ADDENDUM

Project: Del Norte Branch HVAC Replacement

Addendum No.: 1

Date: 6/21/21

SHEET: **ME-1**
 OF: TWO

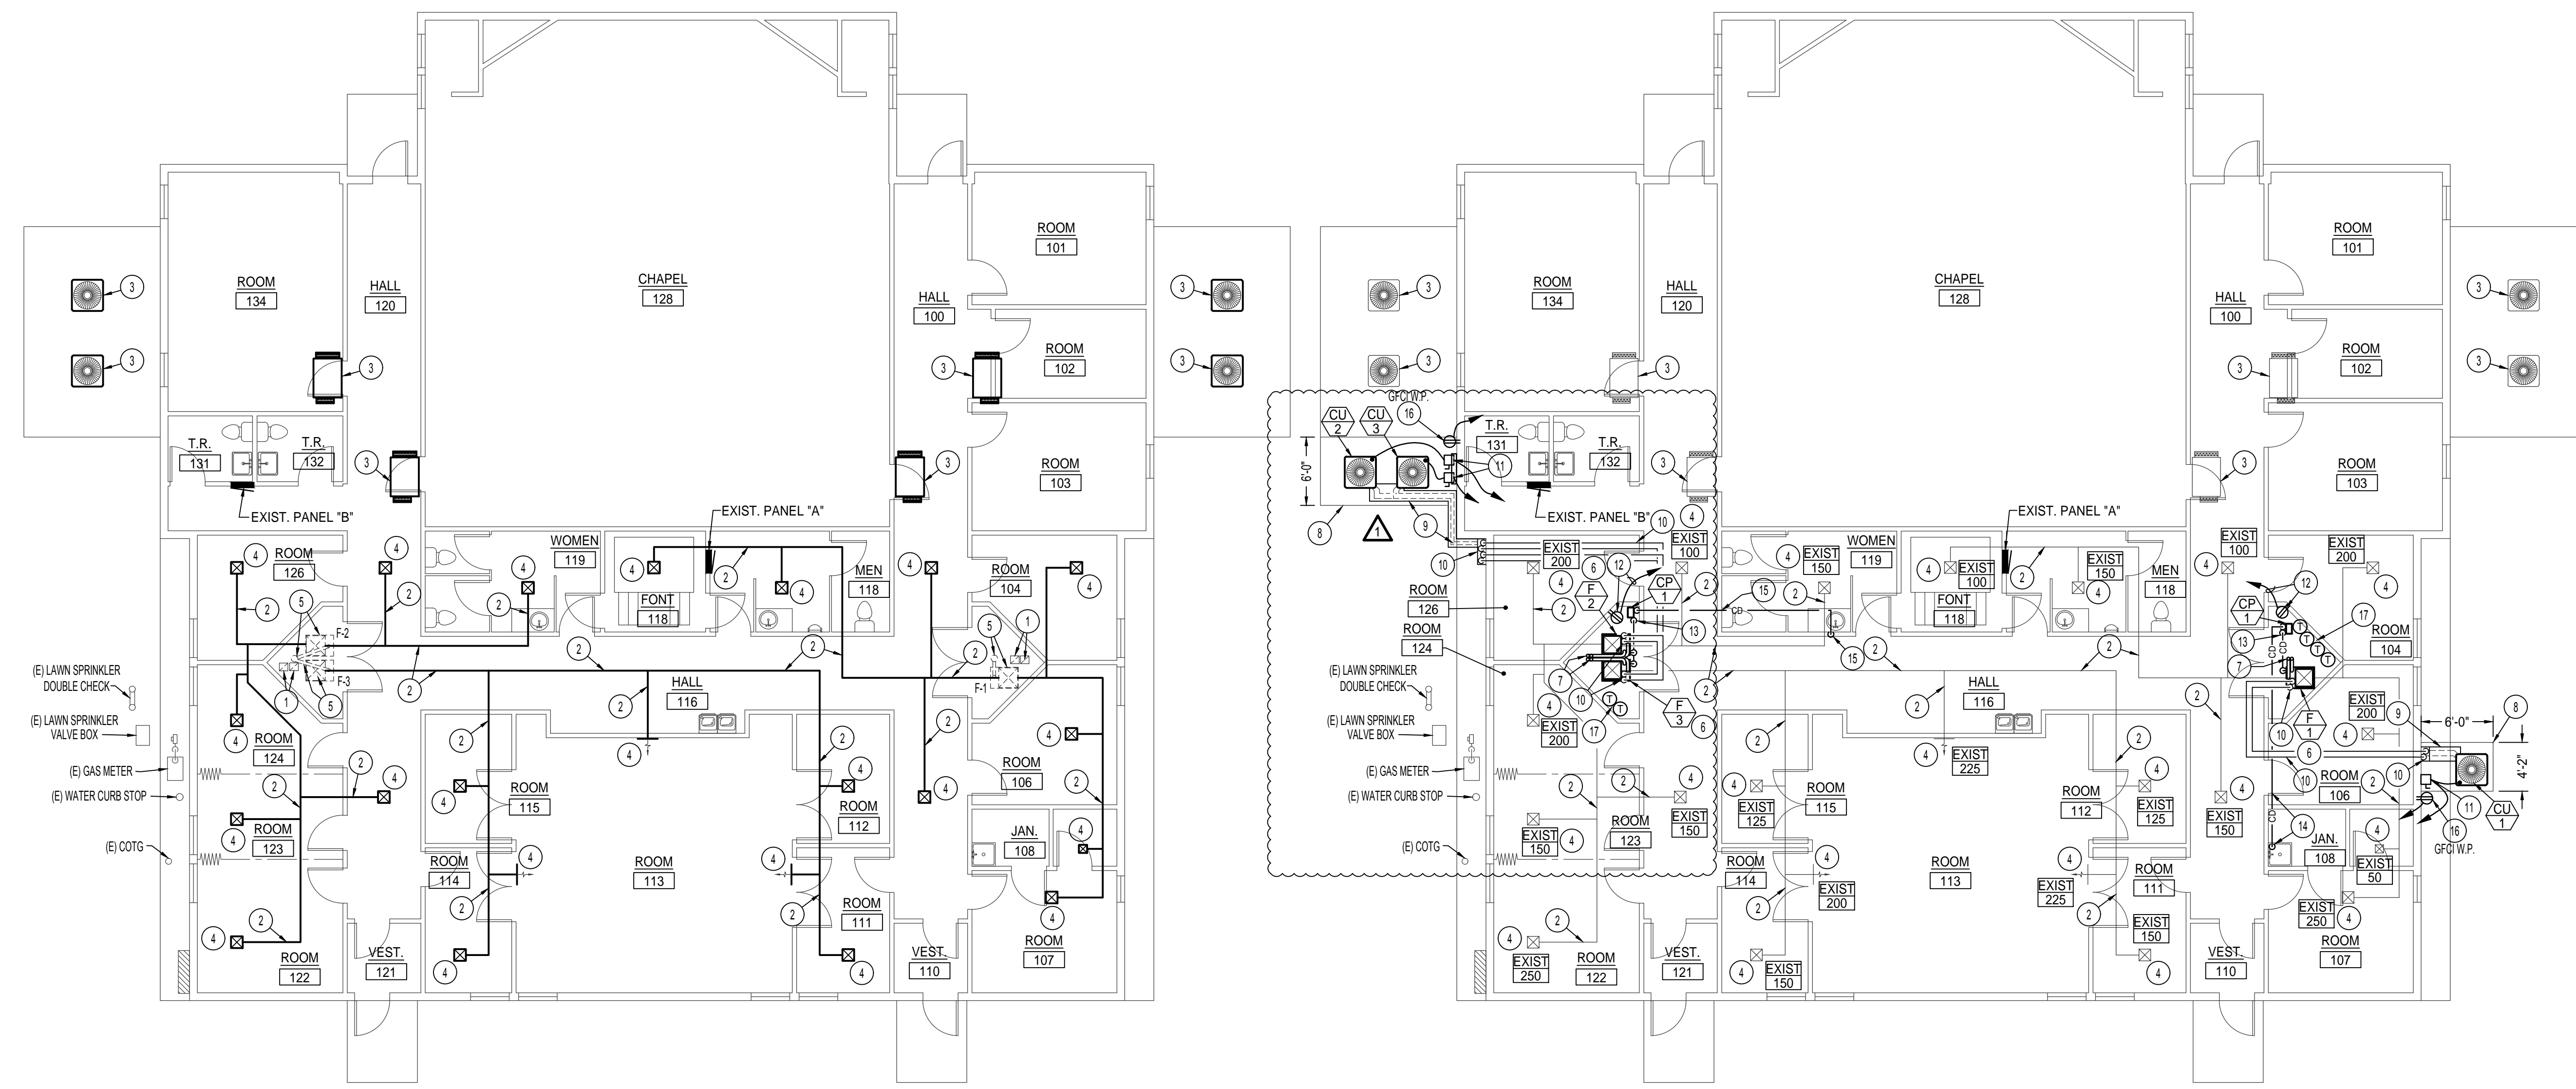
- a. None
4. Changes Specifications:
 - a. None
5. Changes to Drawings:
 - a. See revised Sheet ME-1 to relocate (2) condensing units on West side of building
